# Access Compliance Report

## Public Rights-of-Way

### (Curb Ramps)

Intersection ID: 43353	Main Street: PROSPERITY RIDGE RD	Cross Street: PROSPERITY COMMONS DR	Location: W
ADA ID: 684781FBC8E2	Ramp Type: PerpDiag	Initial Pass/Fail: Fail	Overall Compliance: No
Codes/Mitigation Info/Possible Solution			Severity Score: 10
			Field Measurements/Component Compliance

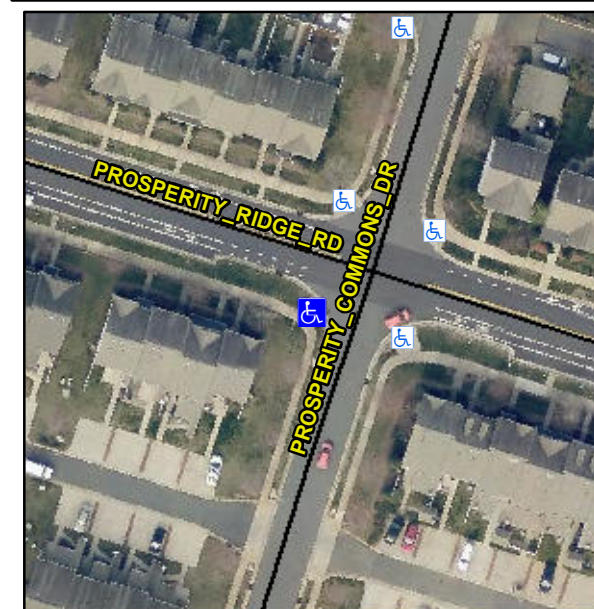
**Not Found, R304.5.1, R304.5.3**

Compliance	Description	Data	Compliance	Description	Data
N/A	Ramp Length (in)	87.0	Yes	Ramp Slope (%)	5.6
No	Ramp Width (in)	42.0	No	Ramp XSlope (%)	2.5
N/A	Flare Type LT	N/A	N/A	Flare Type RT	N/A
N/A	Flare Slope LT (%)	N/A	N/A	Flare Slope RT (%)	N/A
N/A	Flare Traversable LT?	N/A	N/A	Flare Traversable RT?	N/A
N/A	Landing Length (in)	N/A	N/A	DWS Provided?	N/A
N/A	Landing Width (in)	N/A	N/A	DWS Contrast?	N/A
N/A	Landing Slope (%)	N/A	N/A	DWS Length (in)	N/A
N/A	Landing X Slope (%)	N/A	N/A	DWS Full Width?	N/A
N/A	Landing Curb? (Y/N)	N/A	N/A	DWS Offset (in)	N/A
N/A	Shared Landing?	N/A			
N/A	Gutter Ponding?	N/A	N/A	Gutter Slope (%)	N/A
N/A	Gutter Lip Ht (in)	N/A	N/A	Gutter X Slope (%)	N/A
N/A	Painted X Walk1?	No	N/A	Painted X Walk2?	No
	X Walk 1 Direction	To SE		X Walk 2 Direction	To NE
N/A	X Walk 1 Width (in)	N/A	N/A	X Walk 2 Width (in)	N/A
	X Walk 1 Slope (%)	1.2		X Walk 2 Slope (%)	3.6
	X Walk 1 X Slope (%)	4.8		X Walk 2 X Slope (%)	0.1

**Remove & Replace Curb Ramp With Two New Directional Ramps or Equivalent.**
